Subject: Human Factors Engineering - Revised RAI Responses

Enclosure I to  
LD-92-029

REVISED RESPONSES TO NRC REQUESTS FOR ADDITIONAL INFORMATION  
I&C AND HUMAN FACTORS RAIs

**Figure 1**  
Examples of Alarm Coding

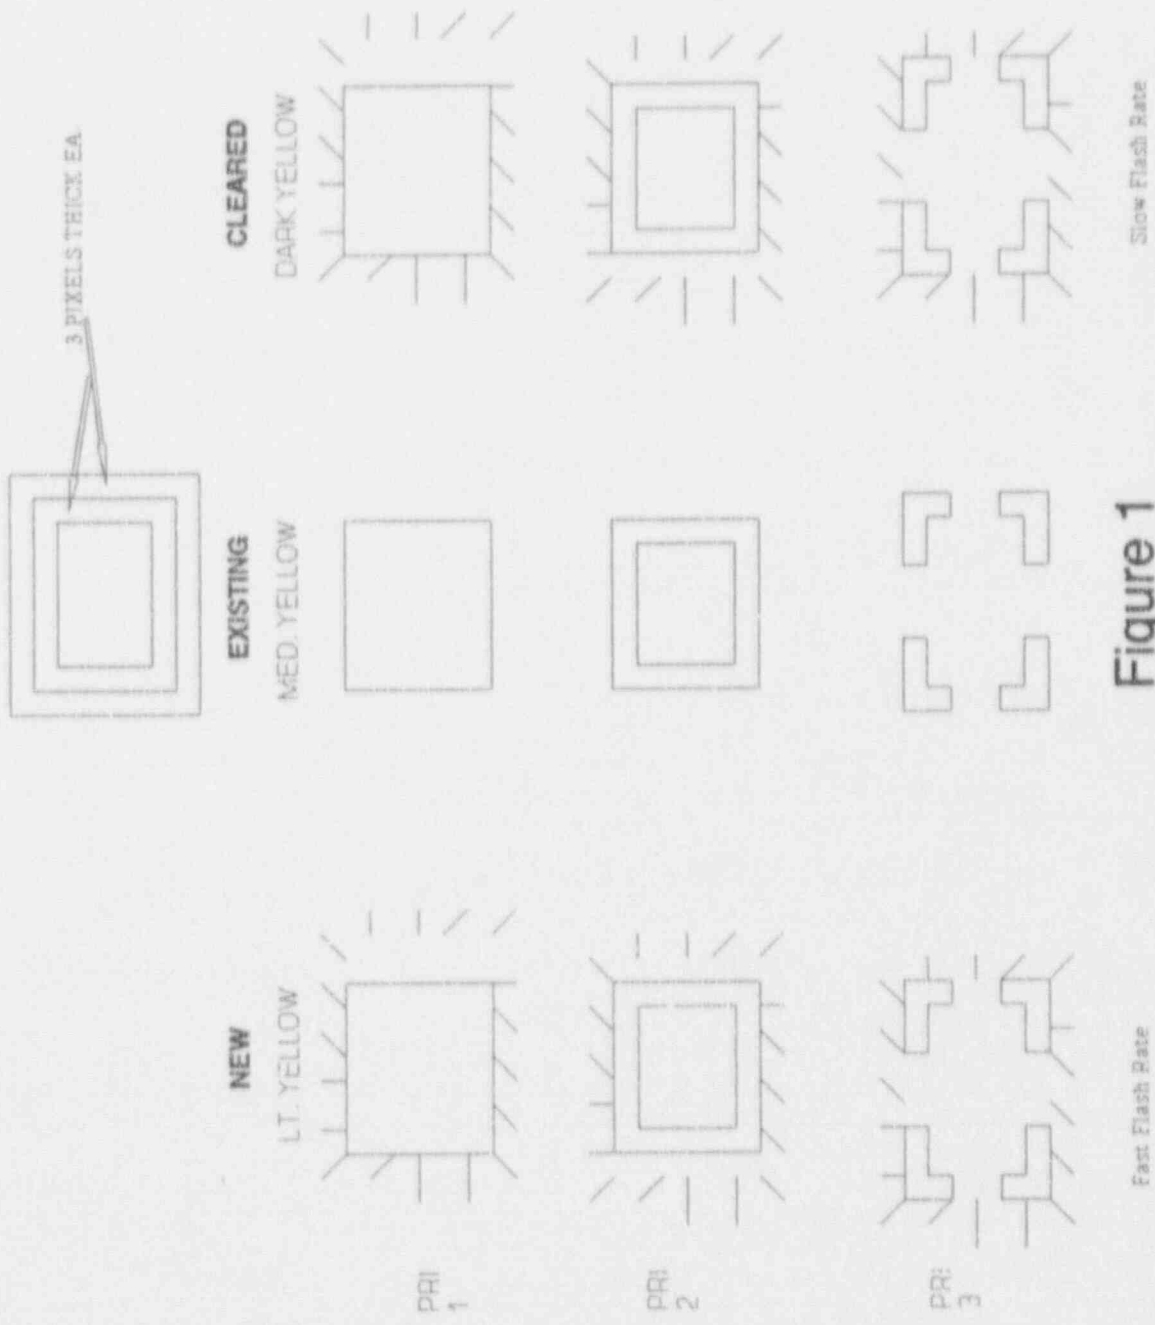
Chapter 18 Section 17.7.1.1.2 describes the use of 11 colors; TE 790-01 Paragraph 3.1.2, Point 1, identifies another two colors; and SD640 Paragraph 6.1.4.1 identifies two or more colors. There is no clear and concise presentation of the information coding scheme used in the System 80+ control room.

Provide a matrix of all the information coding methods and their meanings used in the control room. This would include, at a minimum, the colors, the symbols, changes to alphanumeric and symbols such as case or size, any patterns, position/location/denotation of data that would convey information, flash, flash rate, figure-background changes, reverse video, color changes (include contrast ratios), changes in intensity, etc., or any combinations thereof that are used on software driven and hardwired displays that provide some kind of quantitative or qualitative information to operators or maintenance personnel.

Alarm Priority: Alarms are shape and salience-coded for priority with increasing salience corresponding to higher priority. Salience levels were chosen by empirical evaluation of prototypes. See Figure 1 and Table 1 for details.

Alarm Status: Changes in status of alarms are indicated by flashing and hue, good attention-getting features (per EPRI NP 3659, et. al.). Fast and slow flash rates are used as described in Table 1. Exact flash rates are still to be determined but will fall within the ranges of NUREG-0700. Duty cycles of 50-50 and 25-75 are used as appropriate based on NASA-3000. See Table 1 and Figure 1 for details. Three hues of yellow were selected to allow coding of multiple-status alarm tiles. The 3 hues were acceptable per NASA-3000 and prevented masking, a common problem with multiple input or combined alarms on existing systems.
